Access Compliance Report Public Rights-of-Way (Curb Ramps)

Main Street: IRVINE_BLVD Cross Street: DEL_REY_DR Location: NE

ADA ID: RPRK211014144414 Ramp Type: Type 4 - Parallel Initial Pass/Fail: Fail Overall Compliance: No Severity Score: 15

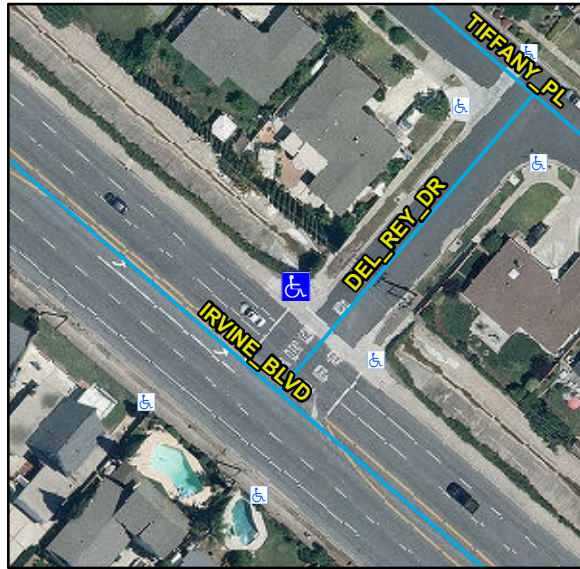
Compliance	Description	Data	Compliance	Description	Data
N/A	Ramp Length LT (in)	85	N/A	Ramp Length RT (in)	82
Yes	Ramp Width LT (in)	79	Yes	Ramp Width RT (in)	96
Yes	Ramp Run Slope LT (%)	7	No	Ramp Run Slope RT (%)	9.1
Yes	Ramp Cross Slope LT (%)	1.7	Yes	Ramp Cross Slope RT (%)	0.3
N/A	Landing Present	N/A	N/A	DWS Provided	N/A
N/A	Landing Length (in)	N/A	N/A	DWS Contrast	N/A
N/A	Landing Width (in)	N/A	N/A	DWS Length (in)	N/A
N/A	Landing Run Slope (%)	N/A	N/A	DWS Full Width	N/A
N/A	Landing Cross Slope (%)	N/A		DWS Offset Type	N/A
N/A	Landing Movement Obstructed?	N/A	N/A	DWS Offset Left (in)	N/A
	Landing Movement Type	N/A	N/A	DWS Offset Right (in)	N/A
N/A	Landing Shared	N/A			
N/A	Clear Space	Yes			
N/A	Clear Space To Crosswalk (in)	N/A			
N/A	Marked Crosswalk 1	No	N/A	Marked Crosswalk 2	No
	Crossing 1 Direction	SW		Crossing 2 Direction	SE
	Marked Crosswalk 1 Width (in)	N/A		Marked Crosswalk 2 Width (in)	N/A

Remove & Replace Curb Ramp With Two New Directional Ramps or Equivalent.

R304.3.2, STD 1115
